Cycle Future Route 5 - Victoria Park

Feasibility Design

Stage 1 Road Safety Audit

Ref: 3288.05.01.01/005/A1205/TLRN

Problem Locations

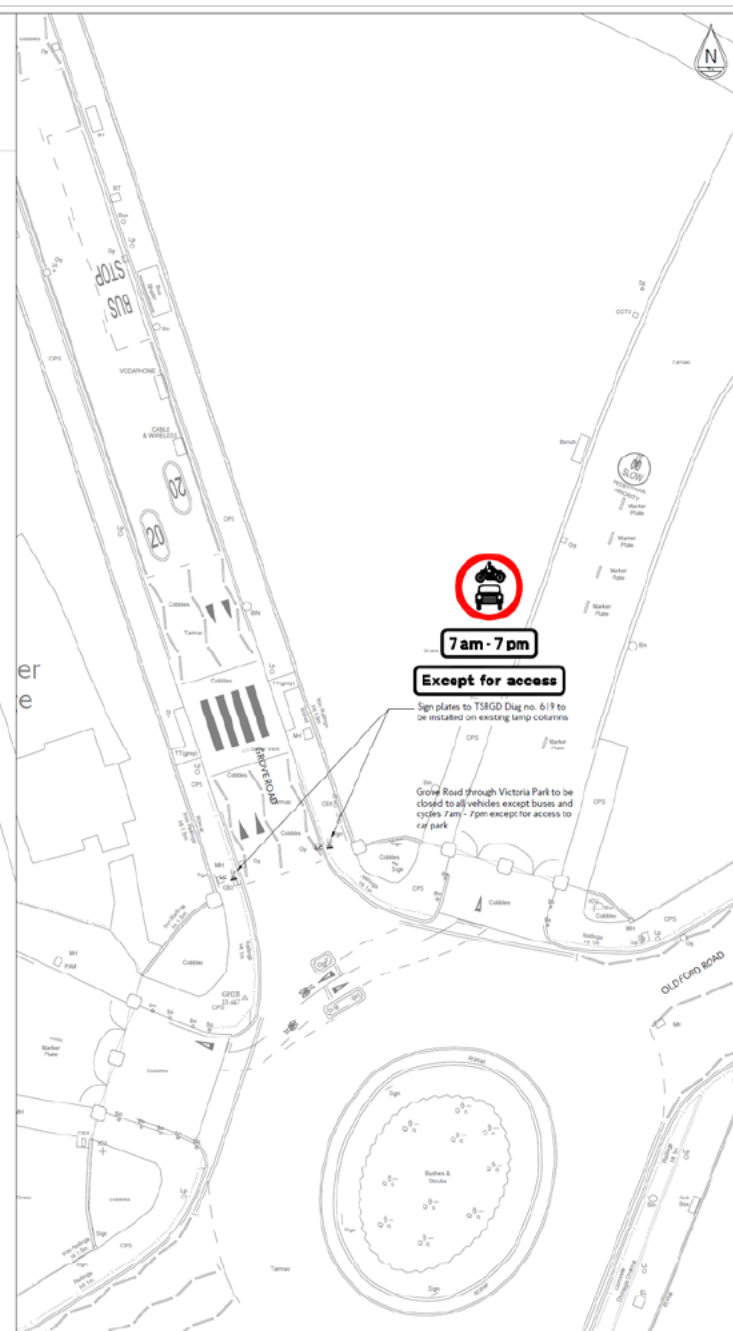
Location: 1 – Grove Road / Old Ford Road roundabout, advanced directional signing.

There is existing map type advanced direction signing on the Gore Road northbound approach to the junction and the Old Ford Road eastbound approach to the junction to inform road users of the weight restrictions on Old Ford Road. It is recommended that advance signing is provided to inform road users of the restricted access through Victoria Park ahead.

Design Organisation Response	Accepted
We are aware of this and plan to address this signage on three approaches to the roundabout at concept design.	
Client Organisation Comments	
The client acknowledges the issue raised regarding the advanced directional signage and agrees with the designs intention to review and update the signage during the next design iteration.
